Access Compliance Report

Public Rights-of-Way

Intersection ID: 54401	Main Street: LOMA_LINDA_LN	Cross Street: AVENAL_LN	Location: NE
ADA ID: FF424C1732EC	Ramp Type: BlendTrans1	Initial Pass/Fail: Fail	Overall Compliance: No
		Severity Score: 8.75

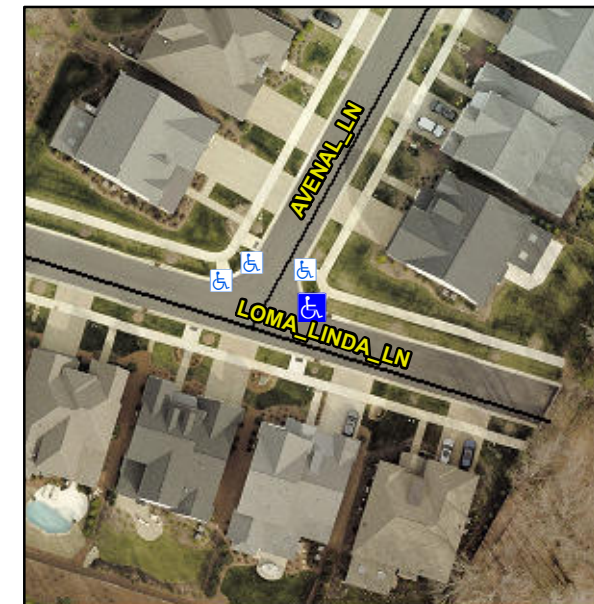
Not Found, R304.5.1

Remove & Replace Curb Ramp With Two New Directional Ramps or Equivalent.
